## GY-HM200/GY-HM170 INSTRUCTIONS Notification of Changes

This is a notification on the addition of new features, feature modifications and onscreen display changes. Please read this together with the "INSTRUCTIONS".

### "98%" added to [Top] and [Bottom] of menu item [Zebra]

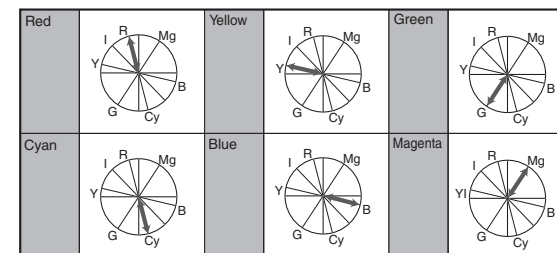
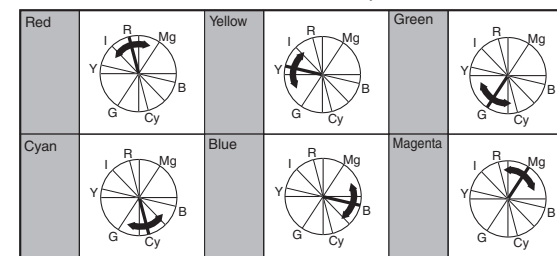
"98%" is added to the setting values for specifying the upper and lower limits of the luminance level in [LCD/VF] → [Shooting Assist] → [Zebra]/[Top] and [Bottom].

This convenient setting is to keep the video level with 100% during the video production for playback, screening and broadcasting on nonlinear devices and PC.

[Top] [Setting Values: 5% to ● 80% to 95%, 98%, 100%, Over]  
[Bottom] [Setting Values: 0% to ● 70% to 95%, 98%, 100%]
